UDPRP Review Summary

Urban Design Peer Review Panel

PROJECT: MLK Medical Office Building

PROPOSED SITE IMPROVEMENTS

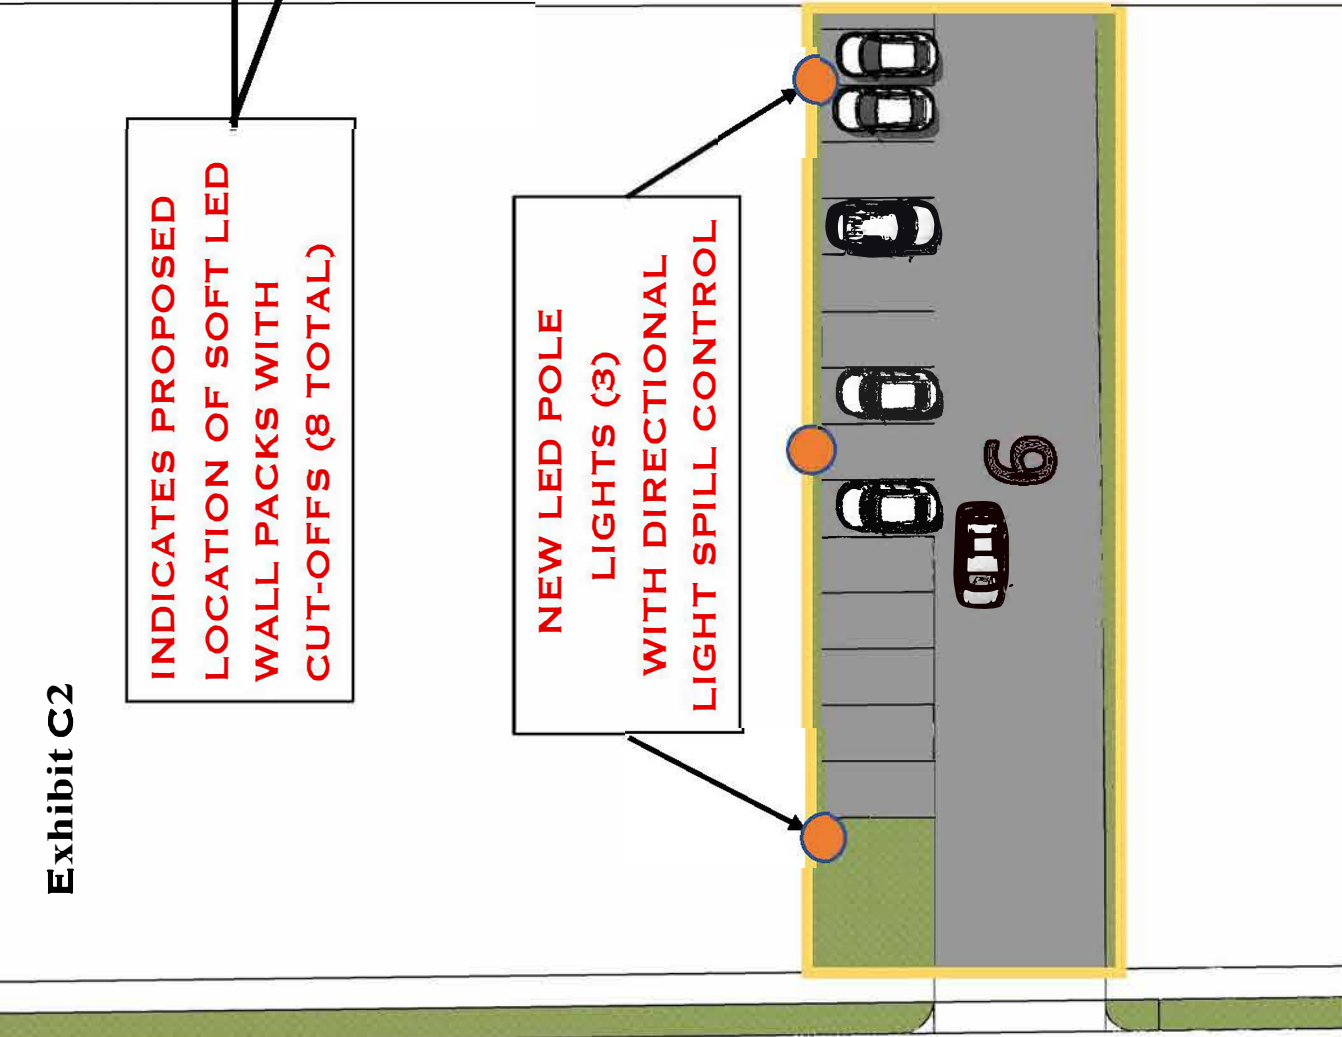
1. The Panel recommends the applicant explore opportunities to reduce the amount of land given up to parking to set the standard for future MLK improvements and help encourage the idea of walking by looking into shared parking opportunities. Consider eliminating or reconfiguring two of the three existing driveway curb-cuts on MLK, creating a shift in parking, and opening opportunities for additional parking elsewhere.

2. The Panel suggests exploring strategies to push sustainability opportunities on the site including permeable paving at the front of the site, as well as designing for water collection and water consumption.

3. The Panel advises exploring the opportunity to maintain the mural in its current location or the reconfiguration, relocation, or reinterpretation of the mural.

4. The Panel recommends similar treatment be given to Peabody Avenue as are being proposed along MLK with respect to landscaping.
5. The Panel advises the parking and dumpster configuration in the rear alley be considered to facilitate its use and meet code requirements.

6. The Panel recommends scrutiny be given to secure pedestrian accessibility from MLK and parking lots to the facility's main entry.
7. The Panel recommends sensitivity be given to site lighting and its impact on neighbors.

8. The Panel advises parking on the side closest to Peabody not encroach past neighbor's front yard.
